Frequently Asked Questions Pennine & North England reactive power service

9 April 2021

Version 1.1

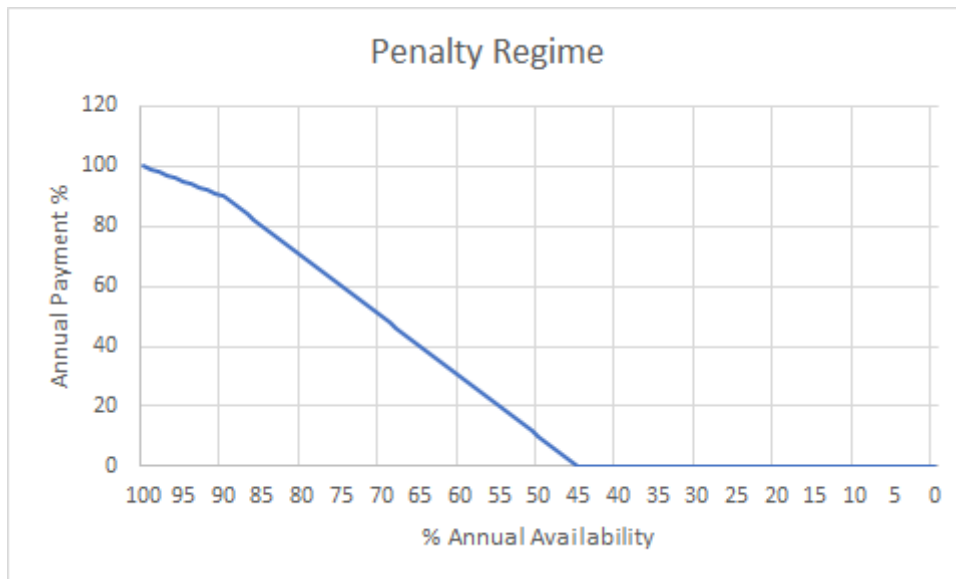
What are the penalties for unavailability? (last updated: 26 Mar)

Providers are required to be available year-round. An annual assessment will be conducted to calculate annual availability based on the number of settlement periods a provider was deemed available. For $\geq 90\%$ availability, providers will be paid their availability fee for the settlement periods they were available.

For availability $< 90\%$ providers will not be paid their availability fee for the periods they are not available and will be subjected to a further penalty equal to the same amount. For avoidance of doubt, penalties will only apply to the unavailability periods below 90%.

The graph below reflects the level of annual payment as a percentage of the maximum annual payment based on annual availability.

- Provider available for 94% of the year.
Availability fee paid for every settlement period provider was available.
- Provider available for 75% of the year.
Annual payment = 75% of maximum annual payment – a penalty of (90-75) % of maximum annual payment
= 60% of maximum annual payment.
